Responses for the HKS Experimental Readiness Review

JLab Hypernuclear Collaboration

This document summarizes the HKS Collaboration response to the comments and recommendations from the first Hypernuclear ERR held on November 18–19, 2024, and documents the current readiness status for the June 2026 ERR.

Figure 1: Beamline geometry for the HKS experiment at Hall C.

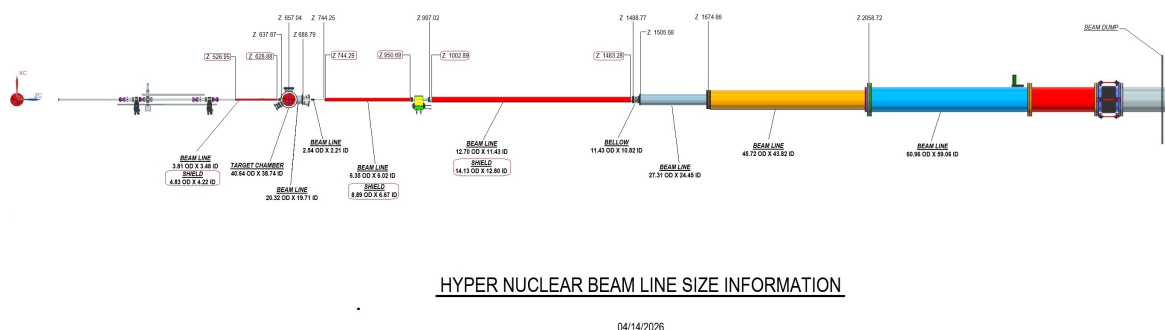
- Insufficient detail was provided on the completion/commissioning schedule for the beamline and scattering chamber. A detailed, resource-loaded (cost and manpower) schedule for design, installation, and commissioning is required.
→ **Response:** See Fig. 1 for reference. The project schedule has been completed and will be presented to the panel at ERR.
